42nd Avenue - Proposed New Residential Construction Project (SDCI #3019962)

SEATTLE DESIGN REVIEW

July 16, 2015 | Early Design Guidance Meeting 1
November 5, 2015 | Early Design Guidance Meeting 2
April 21, 2016 | Early Design Guidance Meeting 3
December 1, 2016 | Recommendation Meeting

4532 42nd Avenue SW
Recommendation Meeting- SDCI #3019962

NORTH SETBACK

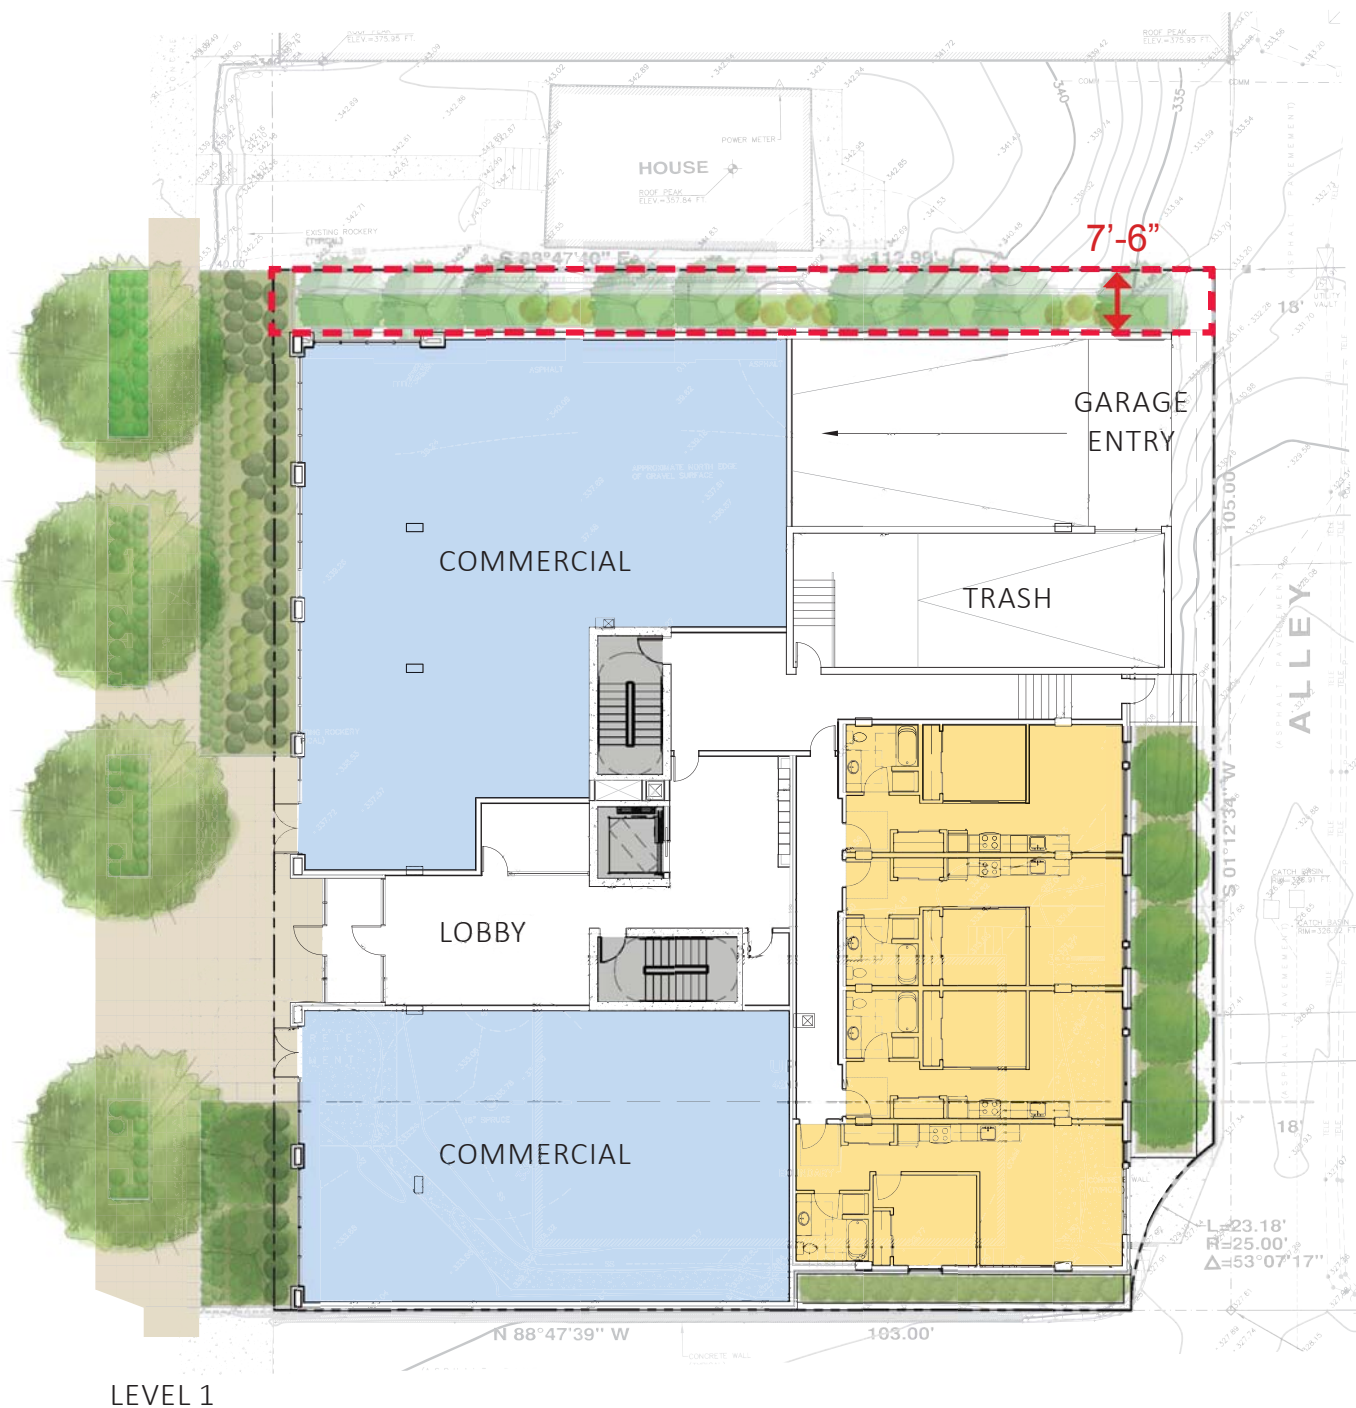
- The board felt that a continuous setback was necessary for providing access to light and air and would create a positive context for future development to respond to.
- The board recommended the structure be set back a minimum of 7.5' from the north property line. No additional modulation is necessary.

The building has been setback 7.5' from the North property line and is now 10' from the residential house to the North. This setback provides the house with sunlight and natural ventilation and will be planted with native plant species and other vegetation to create a natural buffer. Additional articulation has been incorporated to break up the height of the facade and add interest including concrete columns & 8" modulation at white panels. (CS1-B, CS1-D, CS2-B, CS2-D, CS3-A, PL1-A, DC2-A, DC2-B, DC3-A, DC3-B)

TRANSITION AT EAST FACADE

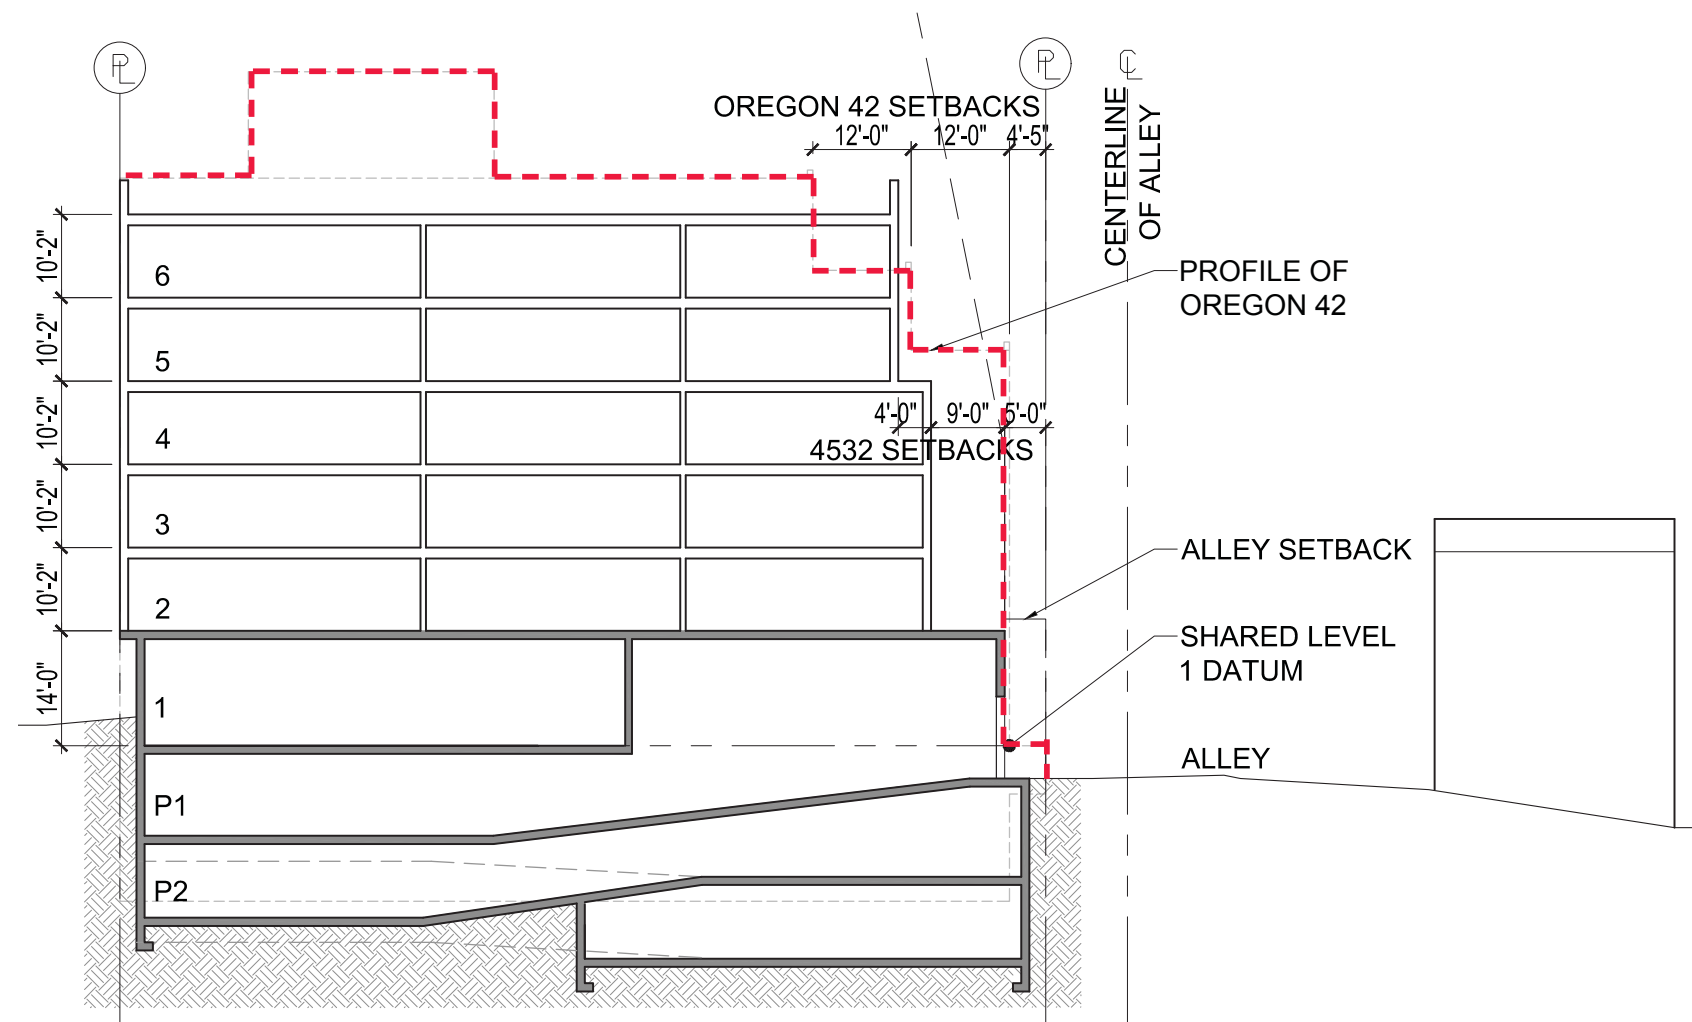
- The board requested the massing be revised to incorporate setbacks at the upper levels to maximize the potential for amenity space at the east of the site to receive sunlight and reduce the perceived height, bulk, and scale of the east facade.
- The board suggested taking cues from the Oregon 42 development for how to provide an appropriate massing transition using upper level terraces.
- The board felt a more linear amenity space along the east would be appropriate for providing access to light

The massing has been revised to incorporate upper level setbacks providing private amenity spaces along the East facade. The design incorporates a stepped design similar to Oregon 42 and provides a more gradual transition to the adjacent LR zone to the East. (CS1-B, CS2-B, CS2-D, CS2-III, DC2-A, DC2-B, DC3-A)

ALLEY & SERVICE USE

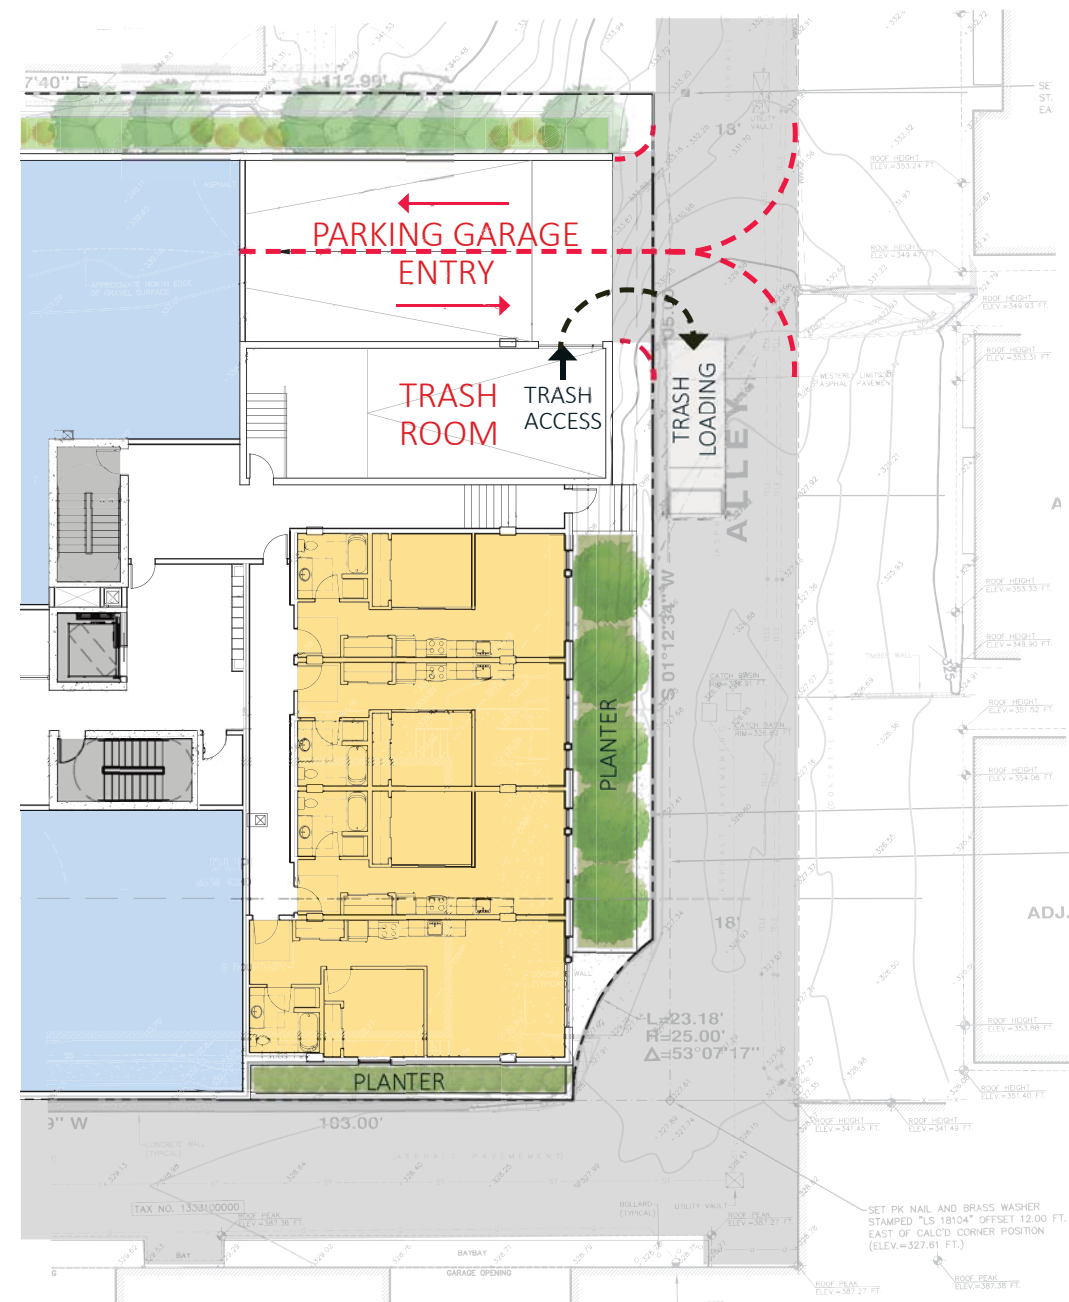
- Access to parking should be limited to one entry to minimize conflicts with pedestrian and vehicular traffic in the alley.
- The entry should be located farther to the north to provide adequate sightlines for traffic turning the corner
- The board supported the planter at the alley, noting that it provides visual relief and improves the scale transition
- The board supported the location of the trash room on the east side of the structure, abutting the north-south alley

Parking access has been limited to one entry and moved to the north end of the site. Two planters remain to provide visual relief and transition from the adjacent LR zone. The trash room is on the east alley and is accessed from within the parking ramp. (DC1-B, DC1-C, DC1-I)
